Monitoring Report – MY5
FINAL VERSION
Lake Wendell Mitigation Project
Calendar Year of Data Collection: 2022

NCDEQ DMS Project Identification # 97081
NCDEQ DMS Contract # 6826
Neuse River Basin (Cataloging Unit 03020201)
USACE Action ID Number: SAW-2016-00876
NCDEQ DWR Project # 2016-0385 V2
Johnston County, NC
Contracted Under RFP # 16-006477
Data Collection Period: March & September 2022
Submission Date: November 30th, 2022

RE: WLS Responses to NCDEQ DMS Review Comments for Task 11 Draft Monitoring Report Year 5 for the Lake Wendell Mitigation Project, NCDEQ DMS Full-Delivery Project ID #97081, Contract #6826, Neuse River Basin, Cataloging Unit 03020201, Johnston County, NC

SPA4, March 30, 2022 (MY-05)

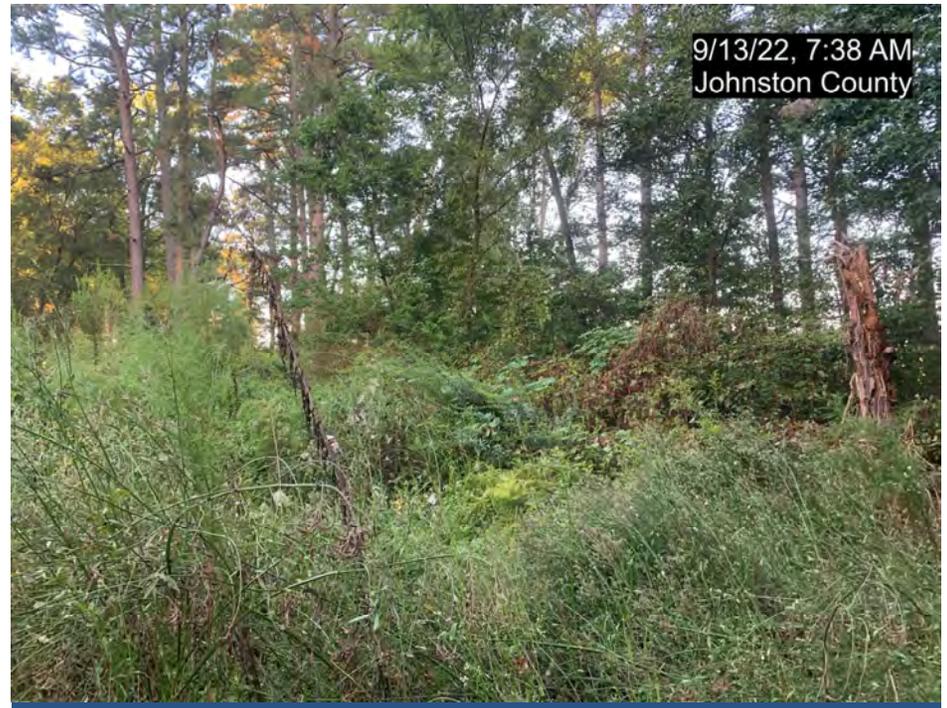
1. **Stream problem area 4 has two separate labels in the photos (repair and new #4) but only a single location has been submitted as a point shape file denoting location. Please verify that both the repair and new problem area are co-located or submit a location for the missing problem area.** WLS Response: Photos of SPA 4 were relabeled for clarity. One new problem area was identified in MY5, SPA 4. There are photos of SPA 4 before repair and photos after repair.

Kudzu Problem Area (VPA1), October 22, 2020 (MY-03)

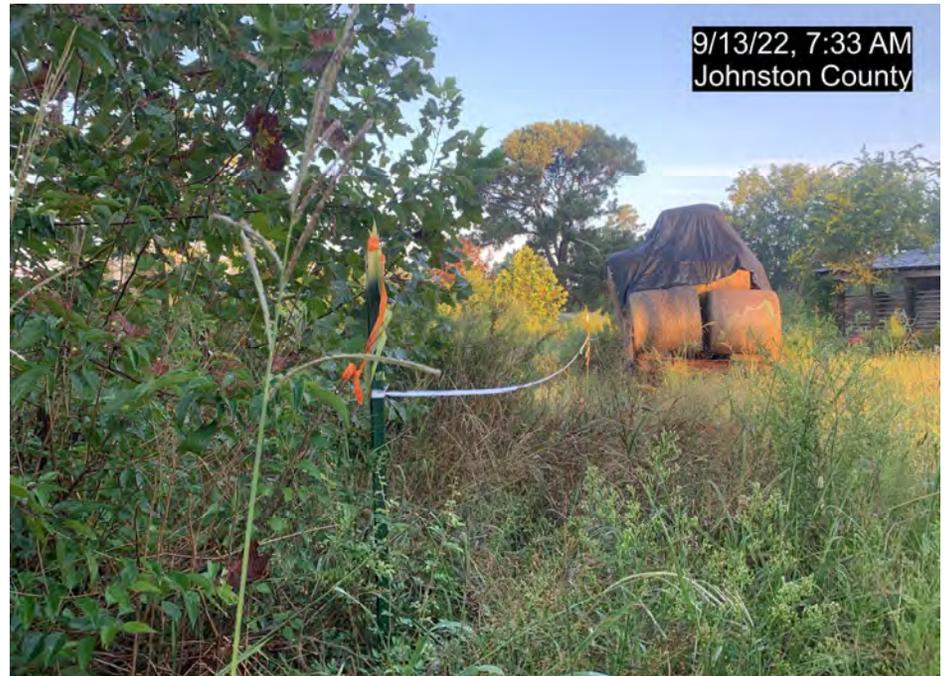
- 3. DMS Comment: The narrative states that VPA1 was re-planted. Confirm if just the vegetation plot was replanted or if the entire kudzu area was replanted and revise statement as necessary. Please also provide the species, area, and number of stems in the replant.** WLS Response: All of VPA1 and the adjacent encroachment (VPA2) were planted during MY4 on February 1st, 2021. The planting list is below and was provided in the MY4 report. Language was added to the report for clarity regarding when the area was planted.

Figure 2: MY5 Cross-Sections
Table 7a: Baseline Stream Data Summary
Table 7b: Cross-section Morphology Data
Table 7c: Stream Reach Morphology Data

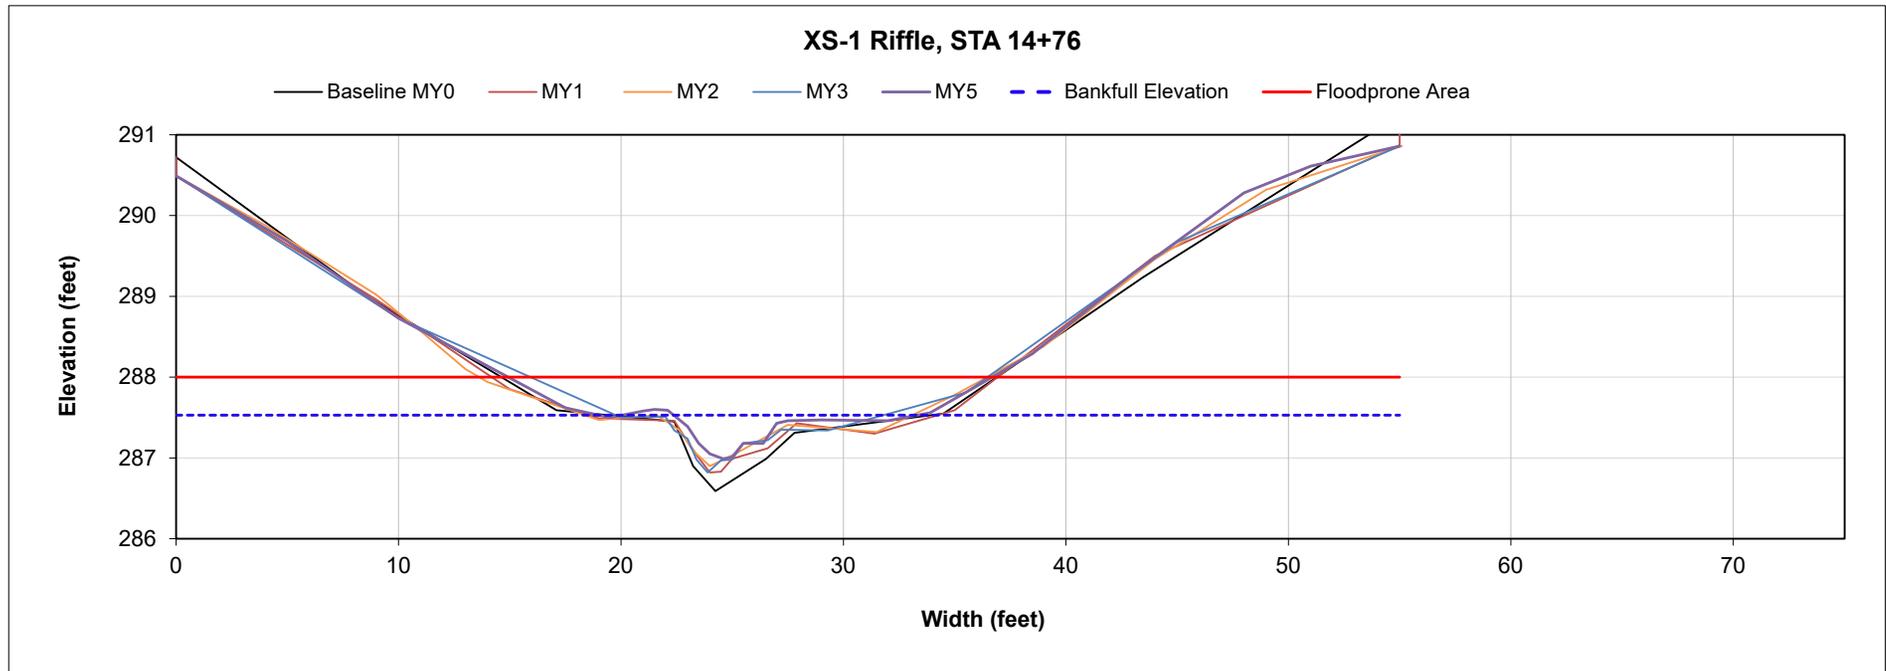
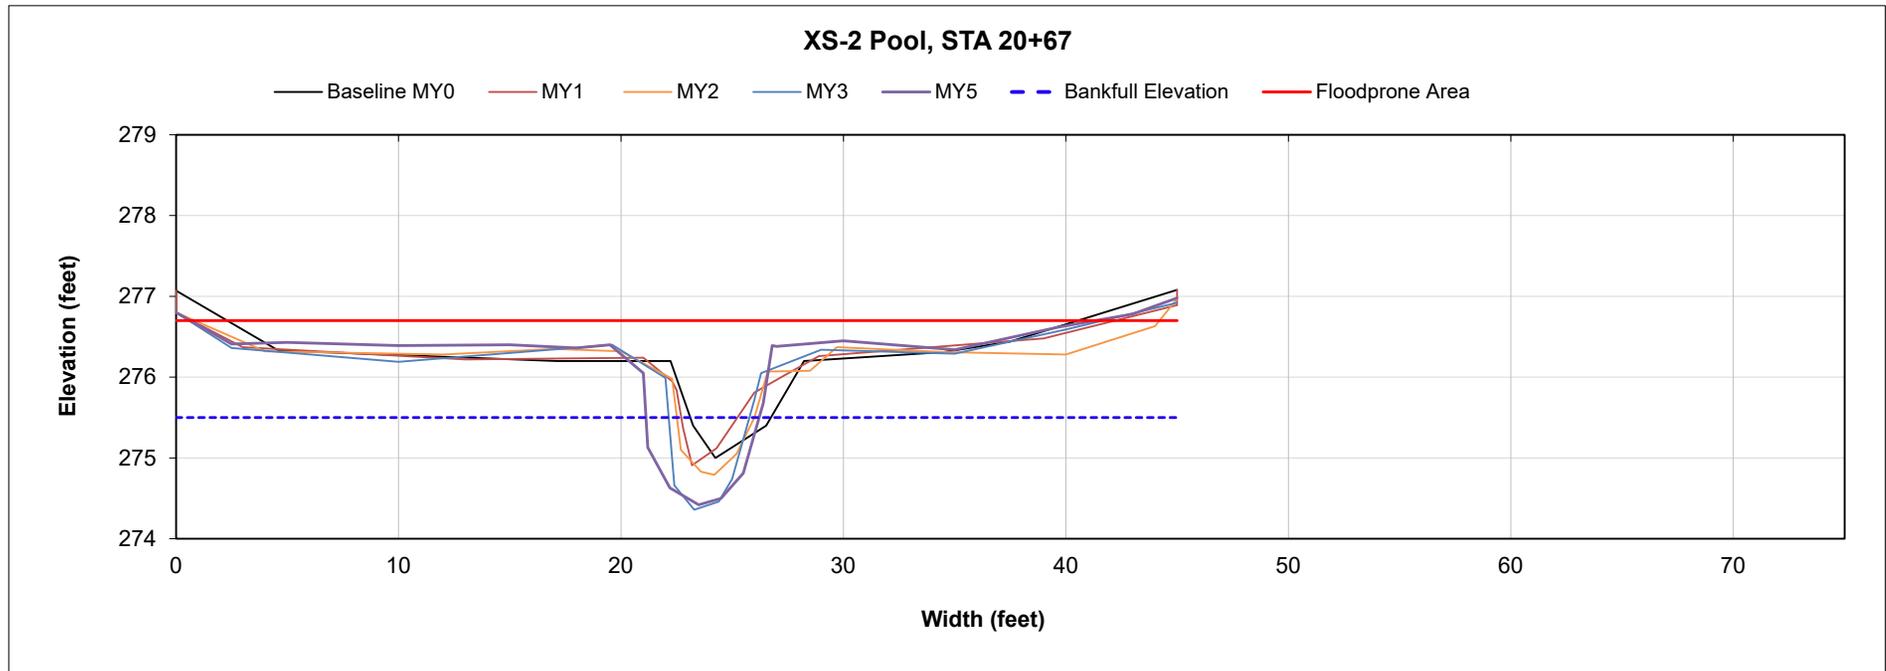
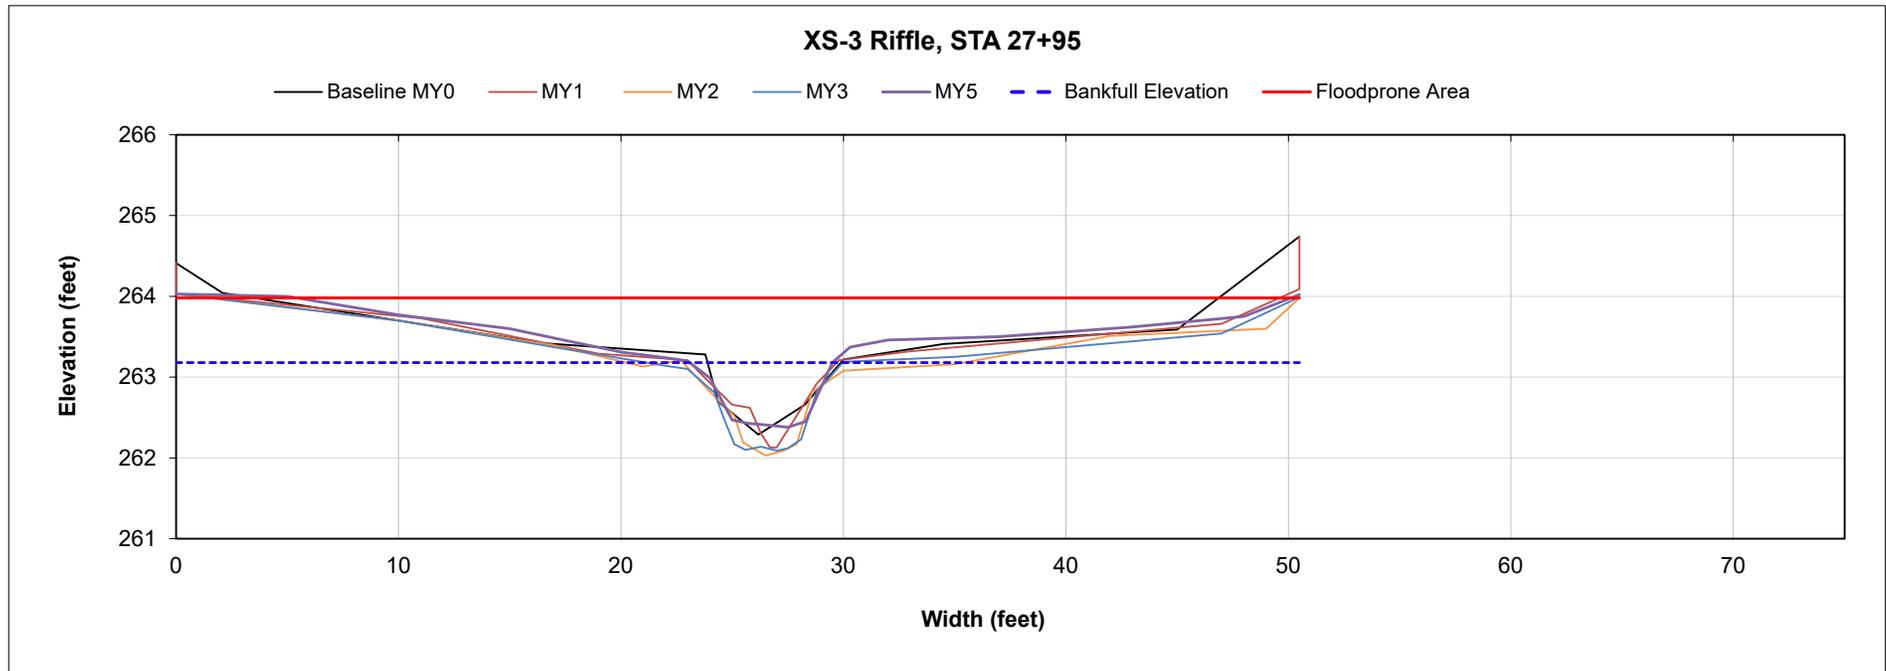
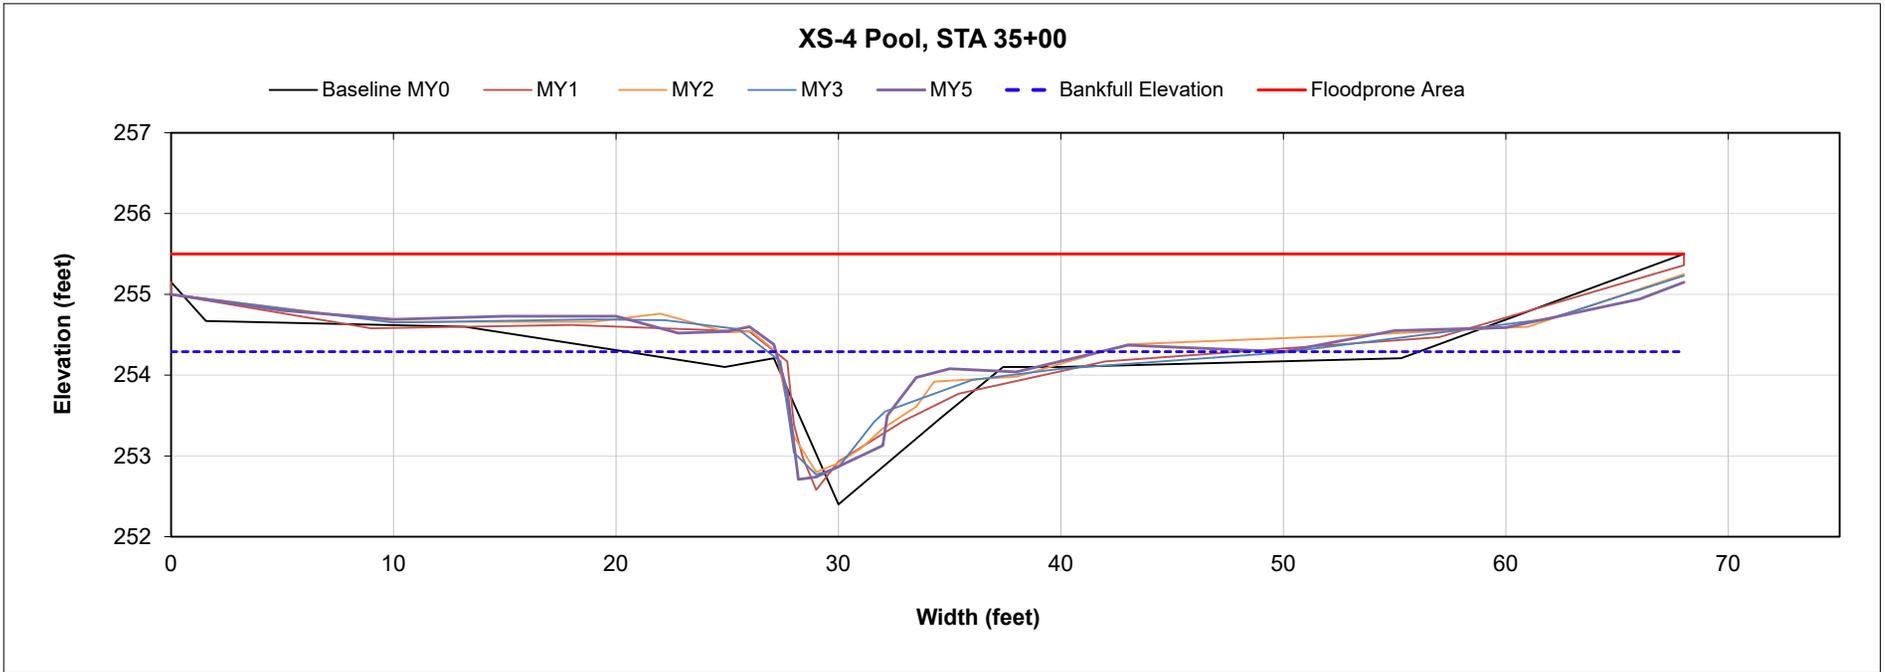
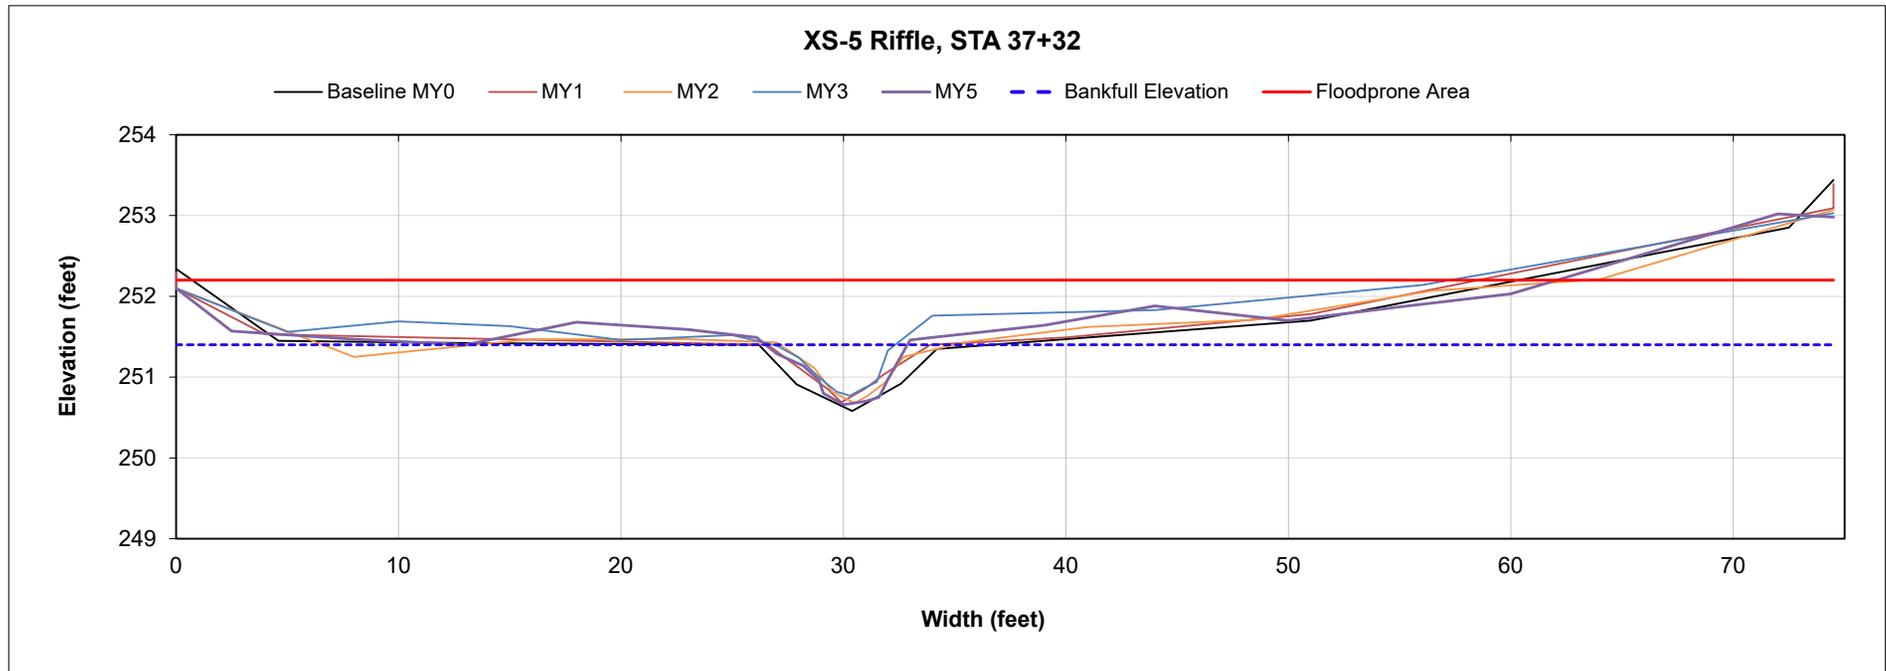
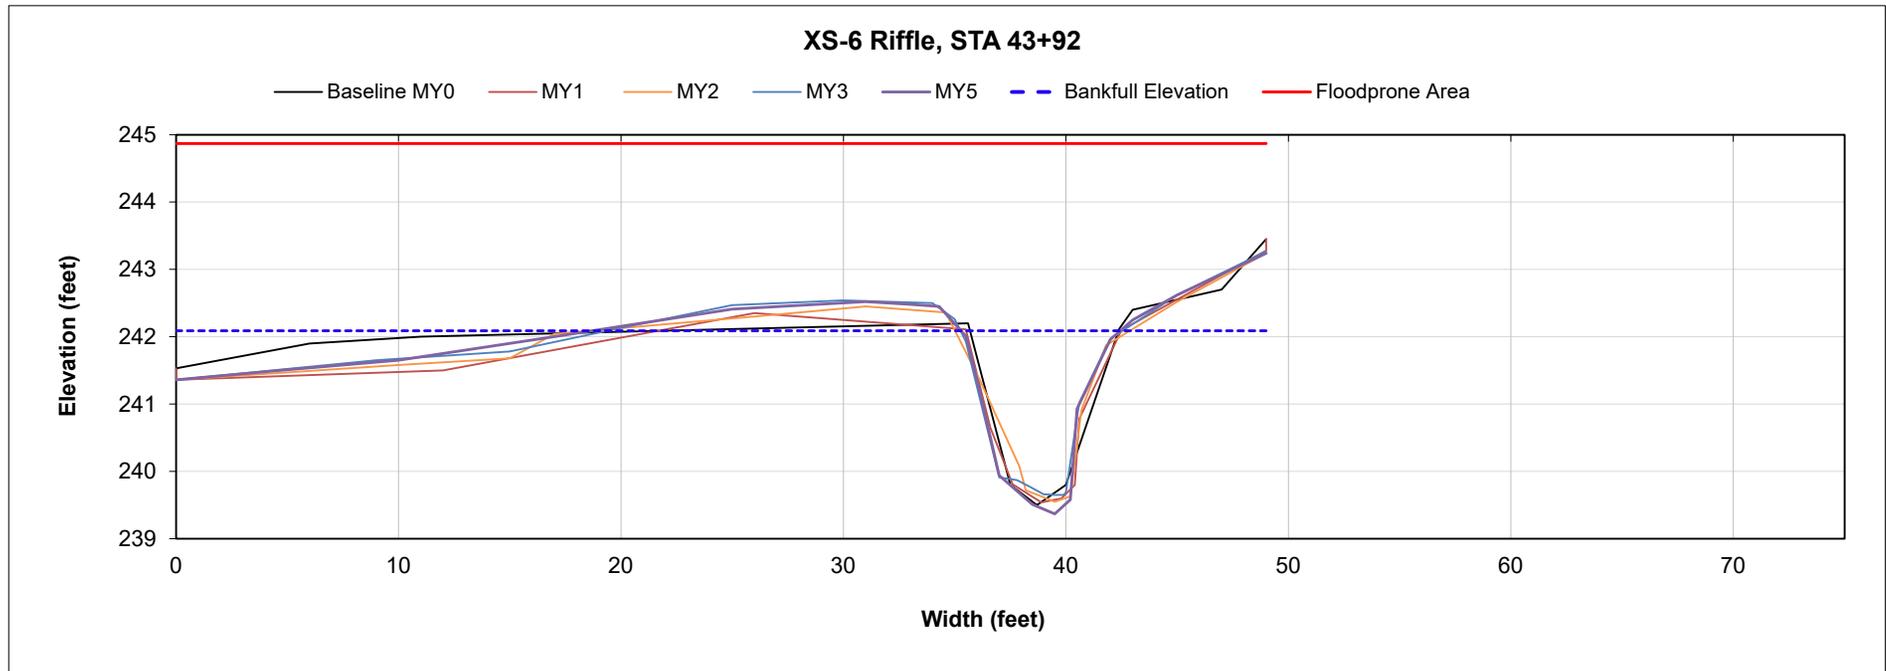
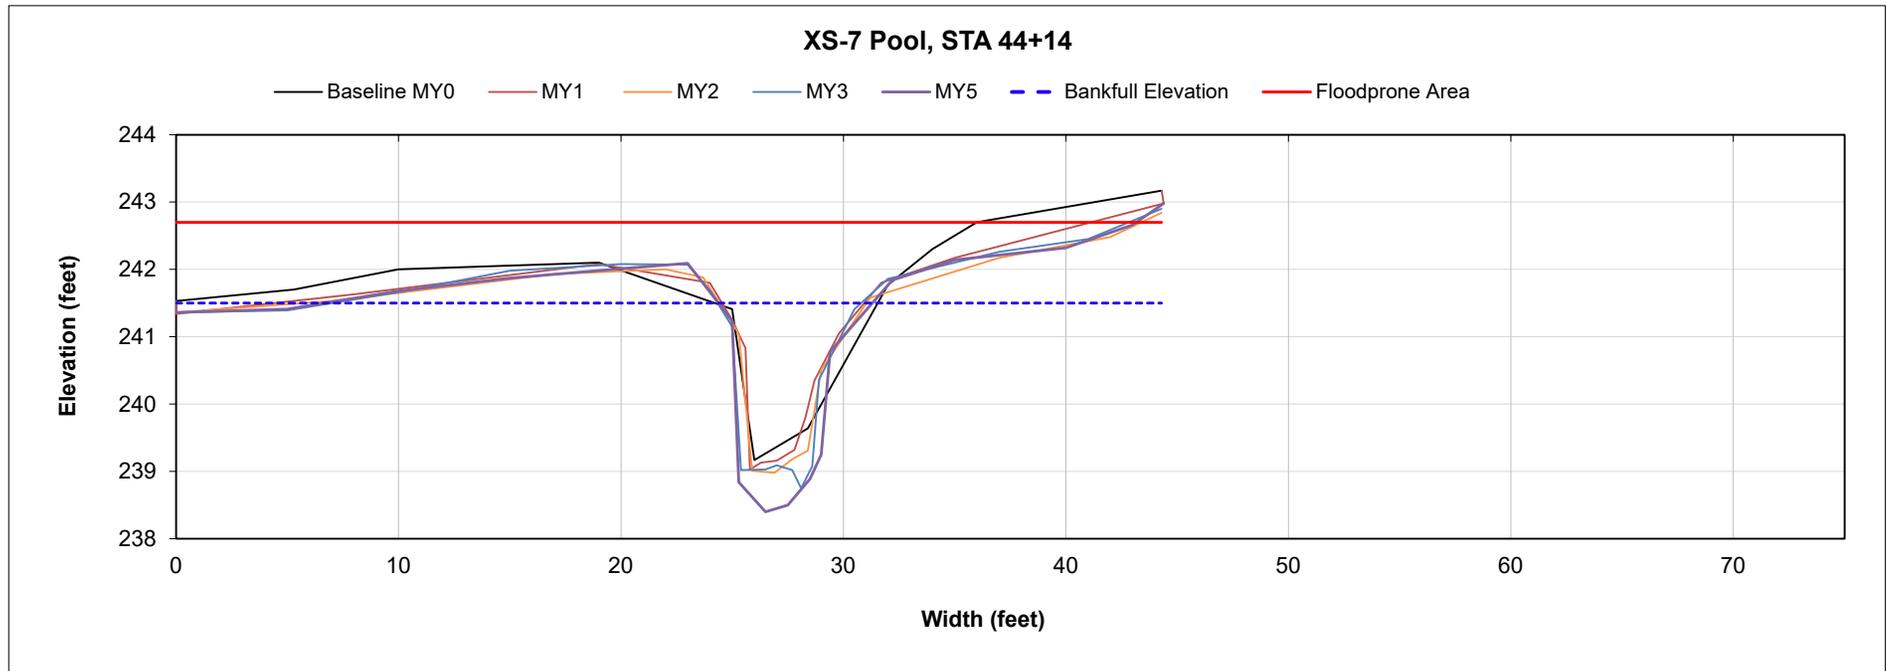
5. **Section 5.2 (p.7) and Figure 2 geomorphic tables and MY5 Cross-sections: The 2016 guidance establishes that BHR should not exceed 1.2 or 10% change per year at any measured riffles, but this does not apply to pool cross-sections. Suggest removing BHR and % change BHR from riffle tables. Consider also revising narrative on p. 7 referring to these changes in pools, which appear to be natural geomorphologic processes for this site.** WLS Response: Language on page seven was updated to remove pool cross-sections and corresponding BHRs. Pool BHR was removed from the riffle table.
